MILITARY SPECIFICATION

MODULES, STANDARD ELECTRONIC

TERMINATOR, INTERFACE, DIGITAL, KEY CODE MDN

This amendment forms a part of MIL-M-28787/111A(EC), dated 10 December 1981, and is approved for use within the Space and Naval Warfare Systems Command, Department of the Navy, and is available for use by all Departments and Agencies of the Department of Defense.

FIGURE 3. Module integrity, continuity, resistance, and capacitance test circuit for tables II, III, IV, and V.

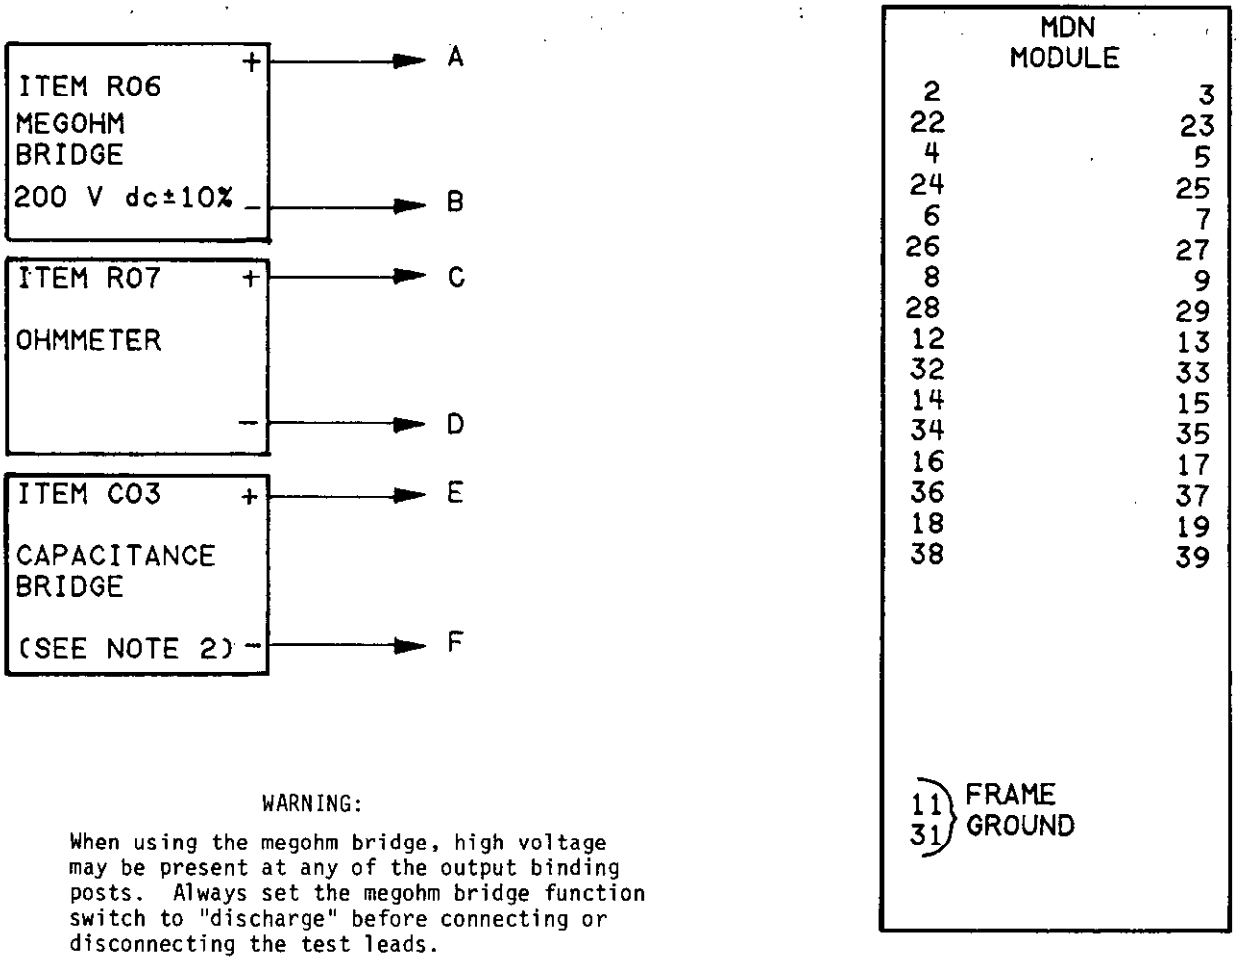
* FIGURE 3: Delete and substitute new figure 3 as printed on page 3 of this amendment.

NOTES:
1. For test condition B2 penetrate the anodized finish on the module frame with a sharply pointed probe connected to the negative terminal of item R07.
2. For test conditions D1-D16:

a. Test fixture and lead capacitance must be measured for each test condition prior to insertion of module into fixture and then subtracted from the capacitance measured with the module inserted. Test fixture and lead capacitance must not exceed 30 pF.
   b. Equivalent series capacitance shall be measured at a frequency of 10 kHz and a bridge voltage of 0.2 V rms maximum.
